## Product Change Notice (PCN)

**PCN Number:** PCN-0374166R-01

Product(s) Affected: CEP-2242

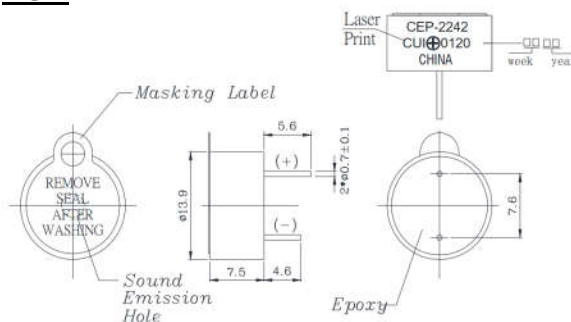
Description of Change: Form has been updated. Pin lengths have increased by .1mm and the diameter has increased .2mm. The height has decreased by .1mm. The sound hole masking label has been updated to cover the top of the buzzer. Function has increased to produce a min sound pressure level of 77dB and maximum current consumption has increased to 15mA. Operating voltage has also been updated to 4~16 VDC.
